Rhode Island Renewable Energy Growth Program:

**Research, Analysis, & Discussion in Support of
Second Draft 2024 Program Year Ceiling Price and Incentive-
Rate Adder Recommendations**

October 24, 2023

Sustainable Energy Advantage, LLC

Interest Rates on Term Debt (1)

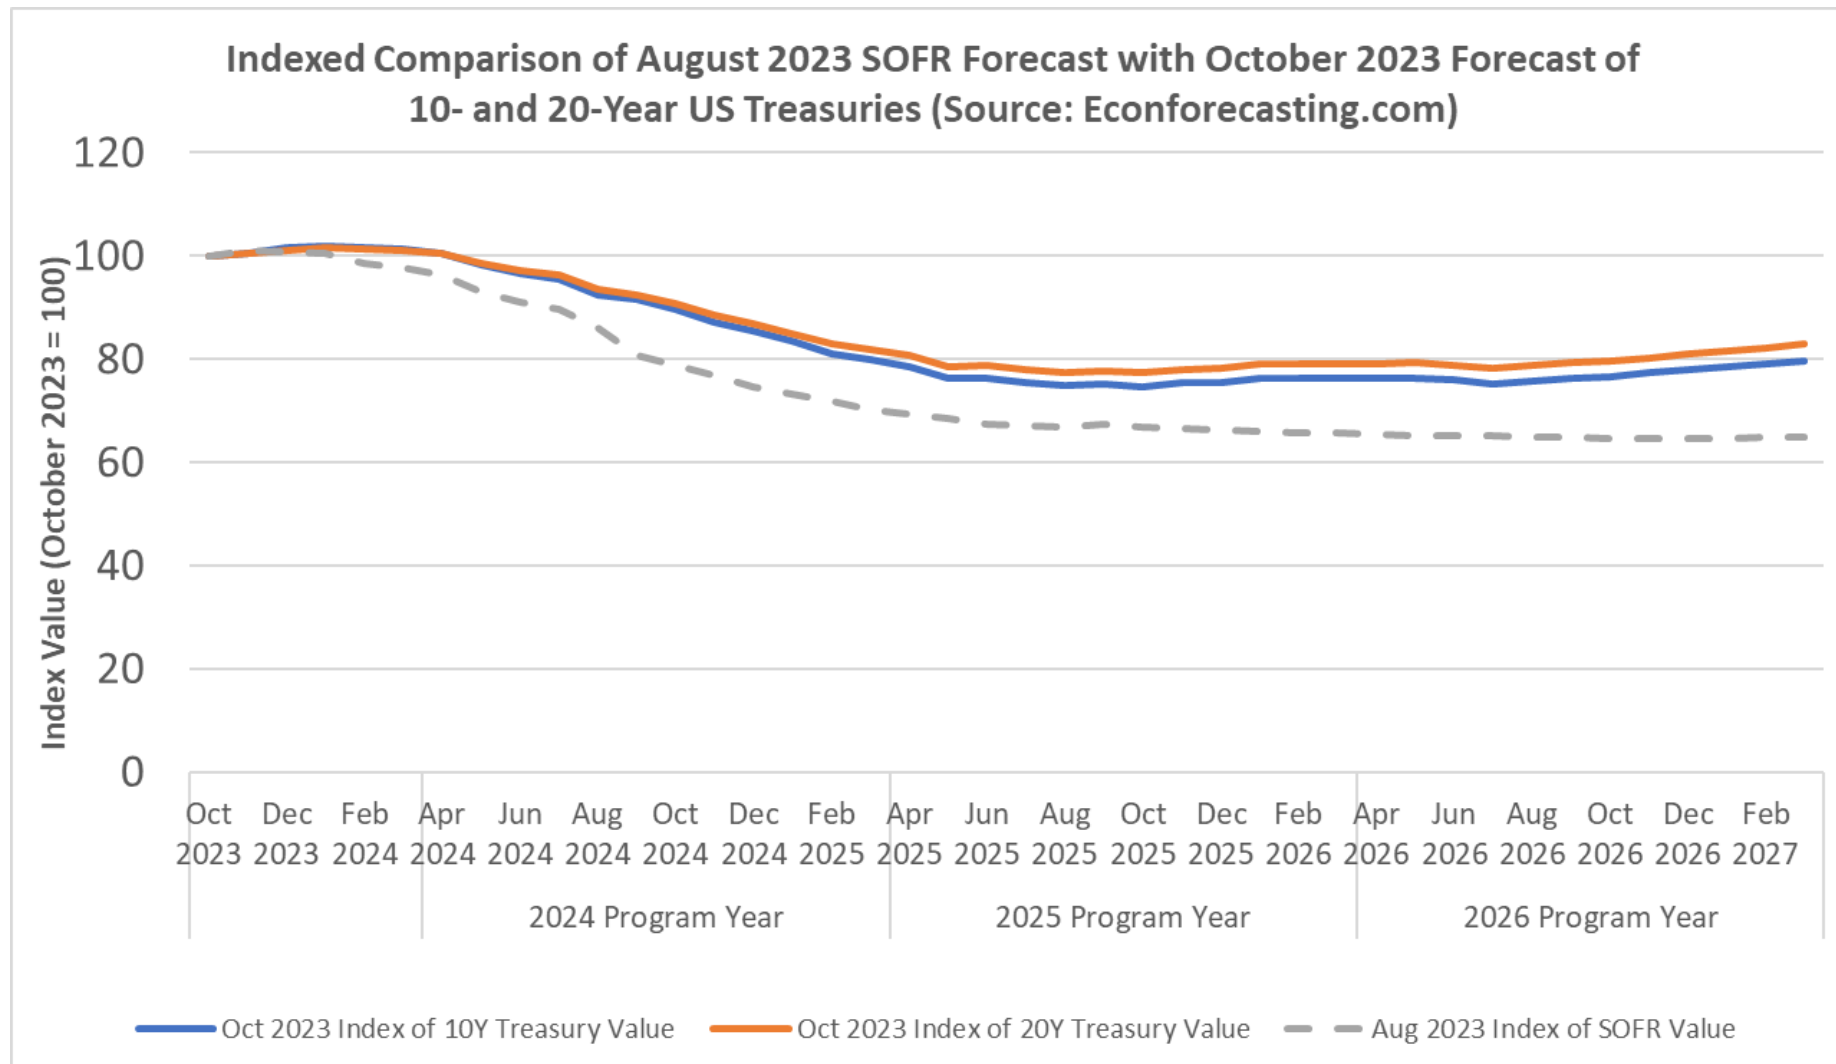
- Despite several requests for financing information, stakeholders **did not submit new information** suggesting that SEA's current approach of taking applicable debt term values was incorrect
- Furthermore, increases in the Federal Funds Rate by the Federal Open Market Committee (FOMC), as well as other market dynamics, **have caused 10- and 20-year Treasury rates to sharply increase in the past several months**
- **M.I.: Revise 2023 starting value for interest rate on term debt to reflect recent market changes**
